PUBLIC UTILITIES COMMISSION

RE: Valley-Ivyglen 115kV Subtransmission Project (VIG) – Minor Project Refinement No. 8 Request: Notice to Proceed- (NTP-) 2 temporary Terra Cotta line and Ivyglen Substation bank

Figure 1. Proposed Work Areas and Disturbances Associated with MPR No. 8.

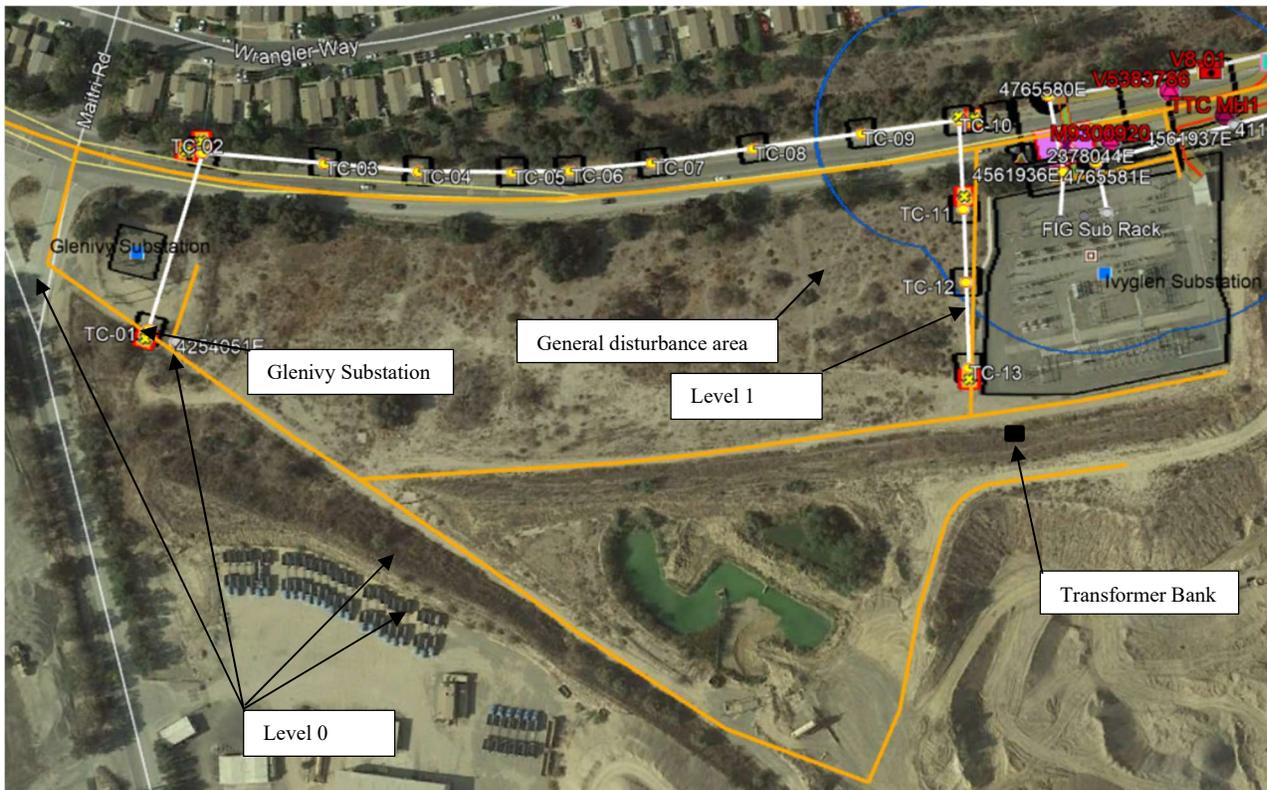
On December 31, 2020, Southern California Edison (SCE) submitted Minor Project Refinement (MPR) No. 8 Request to the California Public Utilities Commission (CPUC) for review. The proposed MPR would involve additional work areas and land disturbances that were not included in NTPR-2 but are necessary to construct the Valley-Ivyglen 115 kV Project. Much of the proposed disturbance is outside of the general disturbance area of the VIG Project (Figure 1).

The proposed refinements would result in a net increase of 0.41 acres of temporary disturbance in Segment VIG8. The locations, dimensions, and activities to occur at each site are provided in Table 1 and are visually shown in Figure 1.
